# ADDENDUM

## PROGRAM ENVIRONMENTAL IMPACT REPORT

### VALLEY COLLEGE FACILITIES MASTER PLAN

**Lead Agency:** Los Angeles Community College District

**Figure 2: Valley College Facilities Master Plan (2006)**

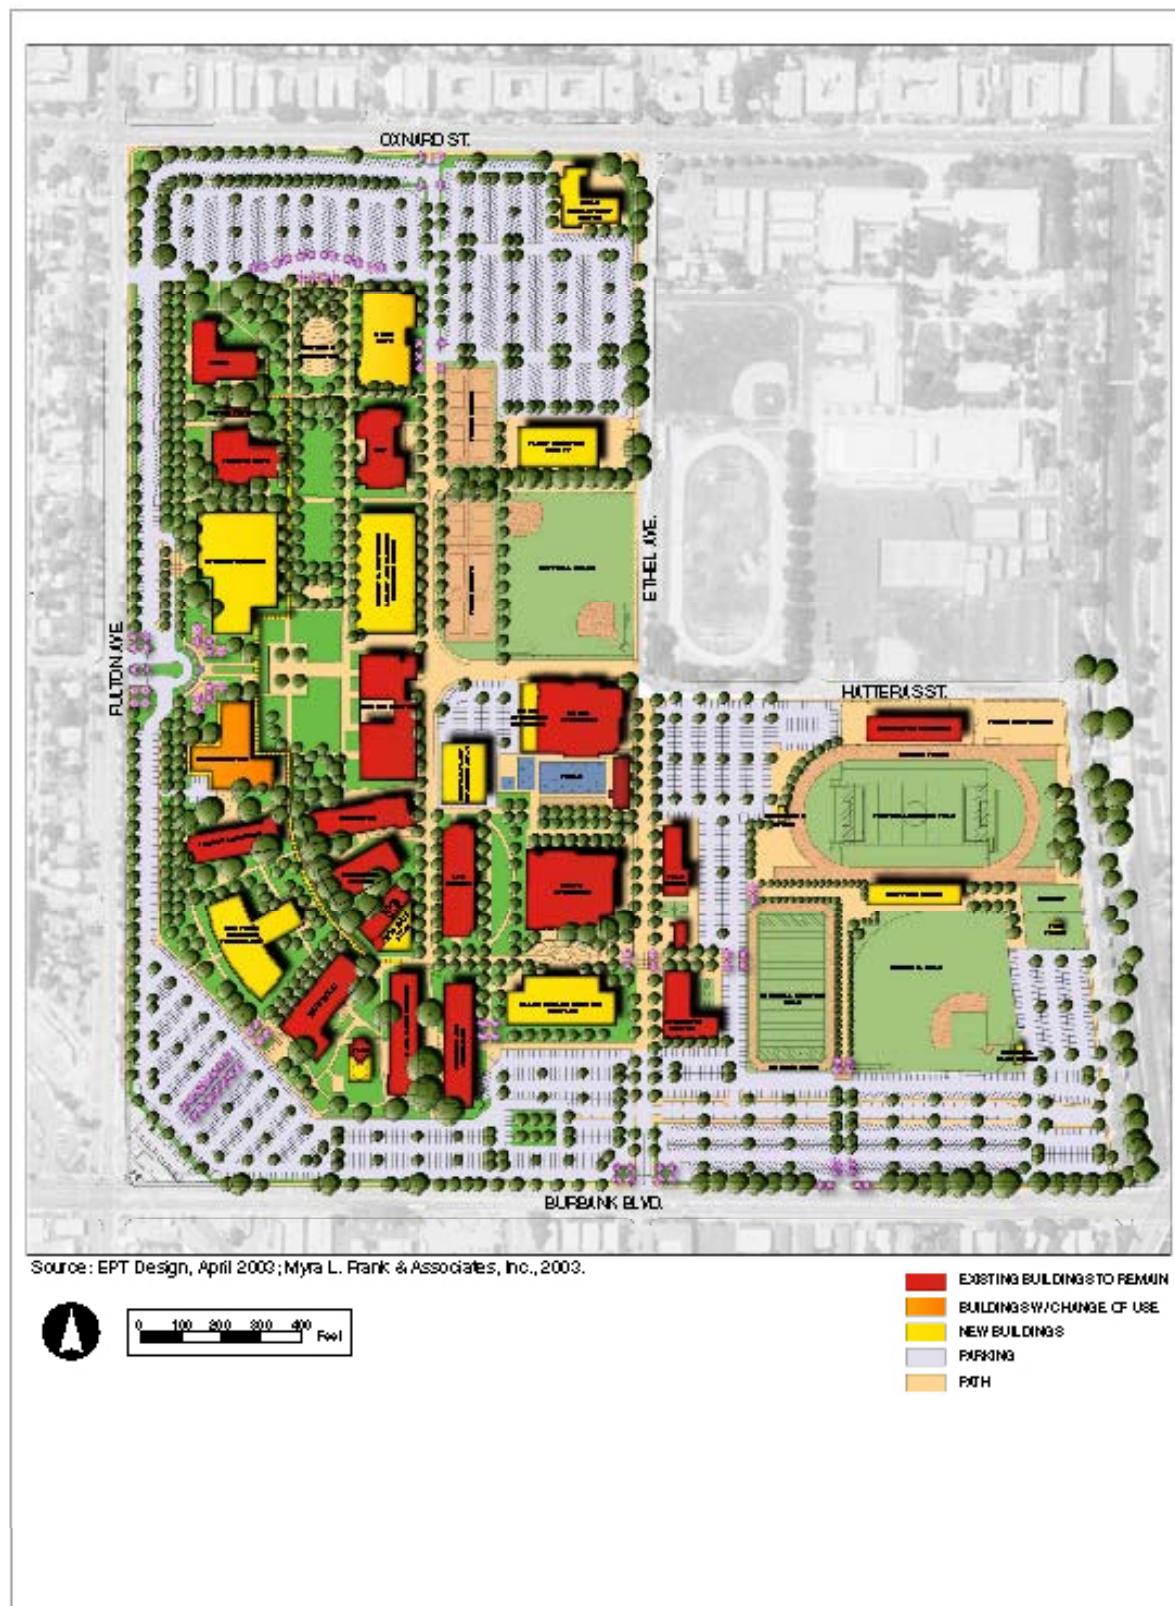
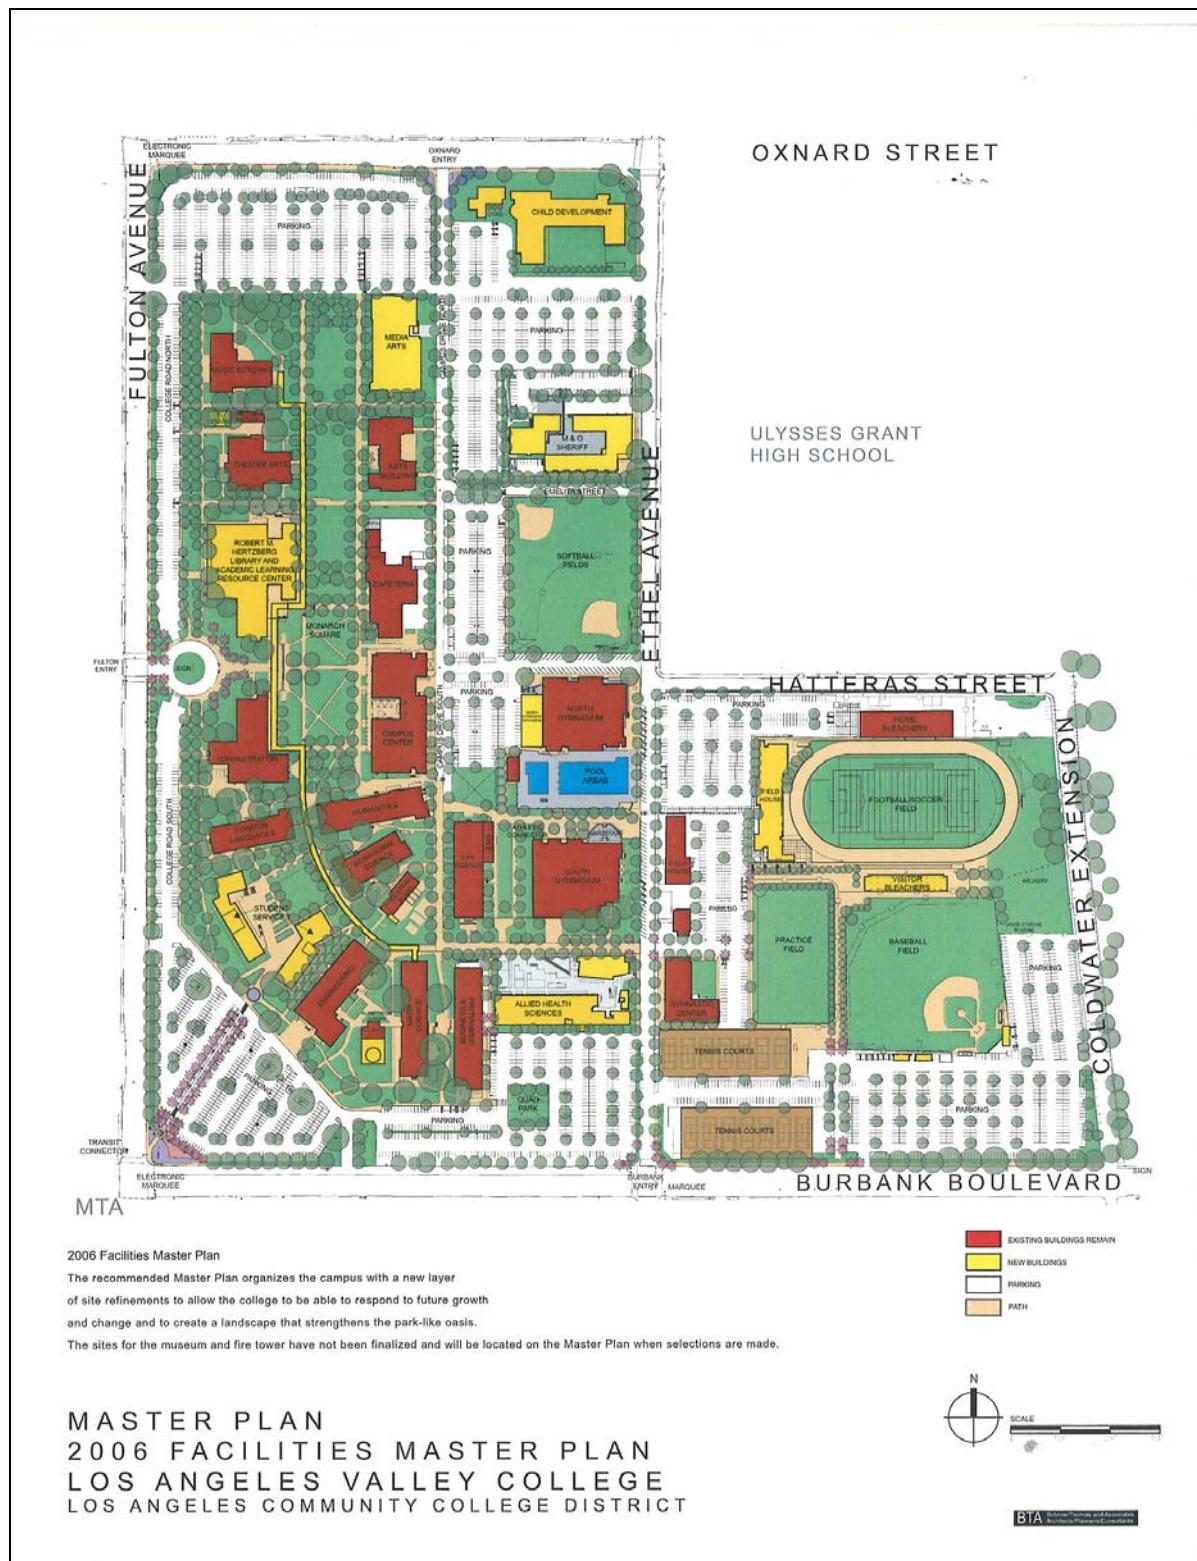
The more substantive changes to the individual components of the 2003 Facilities Master Plan are described below. Table 1 provides a comparison of the major elements of the 2003 and 2006 Facilities Master Plan projects. The current (2006) Facilities Master Plan is depicted in Figure 2.

The 2003 EIR described a new three-story, 108,675-gsf facility to be constructed on the site of the existing cafeteria building, which would be demolished. Under the current (2006) Facilities Master Plan, the cafeteria would remain and the new Library and Academic Learning Resource Building would be constructed on the site of the existing Library. The new Library and Academic Learning Resource Center would be a two-story, 92,000-gsf building.

As described in the 2003 EIR, a new two-story, 80,425-gsf Student Services Center would be constructed on the site of the existing Library Building. Under the current Facilities Master Plan, the new Student Services Center would be constructed on the site of the existing Physics and Chemistry Buildings. The Student Services Center would contain two buildings (one two stories, the other one story) containing a total of 40,000 gsf.

The 2003 EIR described the construction of a new three-story, 103,155-gsf facility south of the existing South Gymnasium and west of the existing Gymnastics Center, on the site occupied by Plant Facilities and a number of bungalow facilities. The 2006 Master Plan proposes a three-story, 98,000-gsf building in approximately the same location.

In the 2003 EIR, a new 15,550-gsf building Child Development Center (CDC) was proposed on the site of the existing CDC. Under the 2006 Master Plan, a 1-story, 26,000-gsf CDC building would be constructed on the site.

The 2003 EIR described a new 1-story, 12,000-sf Field House on the south side of the Football/Soccer Field. The 2006 Master Plan proposes a 1-story, 24,000-gsf facility on the west side of the Football/Soccer Field. New 1,500-seat bleachers would be constructed on the south side of the football field in place of the Field House proposed in the 2003 EIR and Facilities Master Plan.

Notwithstanding the proposed revisions in the square footage of Master Plan projects (see discussion above and Table 1), and changes in the footprint of four of the buildings (see Figure 2) from what was shown in the 2003 EIR, the size, height, massing, and location of the proposed Facilities Master Plan projects would generally be similar to what was previously proposed. Additionally, as shown in Table 1, the overall size and scale of the new development projects under the current 2006 Facilities Master Plan are generally similar to or less than those proposed in the 2003 Master Plan. Consequently, as discussed in further detail below, these changes are not expected to result in new significant impacts not previously analyzed in the 2003 EIR.

### **Figure 2-5: Proposed Master Plan Development**

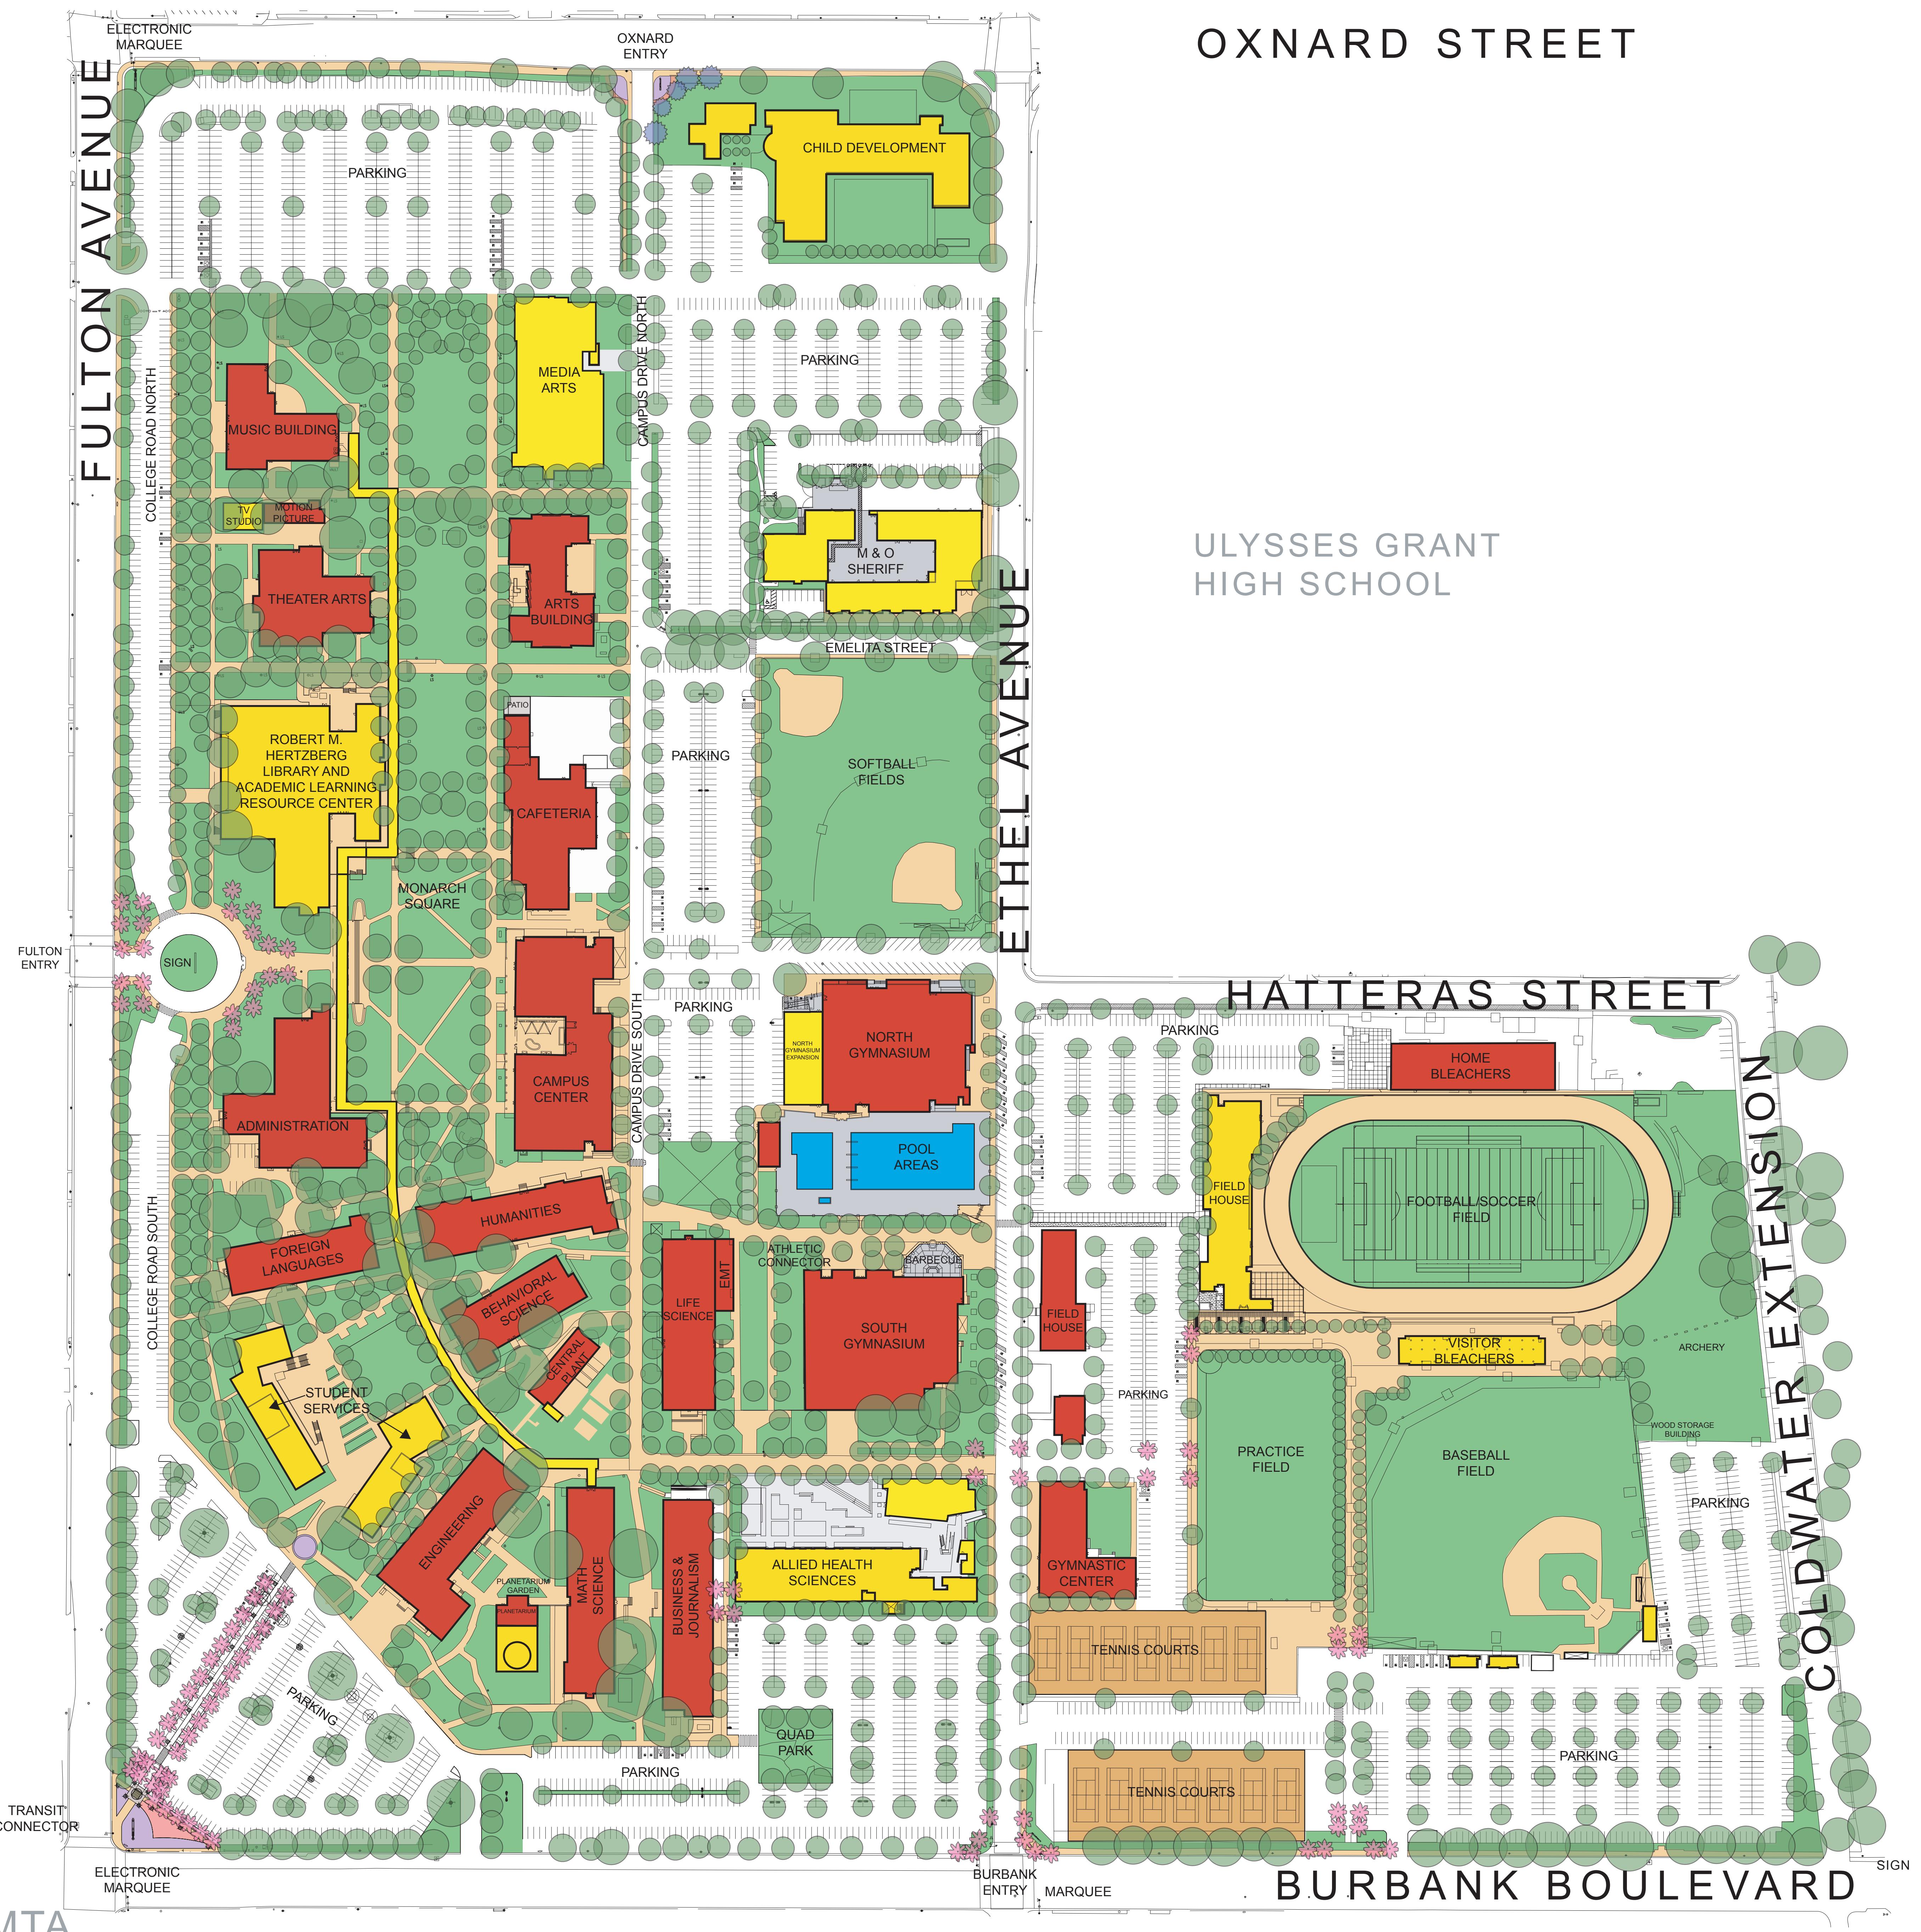
Master Plan would result in a net increase of approximately 17 and 34 spaces on the north and west sides of the campus, respectively, and a net decrease of about 53 spaces on the south side of the campus, compared to the 2003 plan (see attached Draft Technical Memorandum by Kaku Associates). The changes in parking between the 2003 and 2006 Master Plans are largely a result of elimination of the tennis courts west of the softball field and construction of new tennis courts south of the Gymnastic Center and practice field. As shown in the attached memorandum, the 2006 Master Plan would provide a total of 4,168 parking spaces within campus parking lots and on internal campus streets (plus 105 spaces on adjacent public streets) as compared to 4,170 spaces (plus 219 spaces on adjacent public streets) under the 2003 Master Plan.
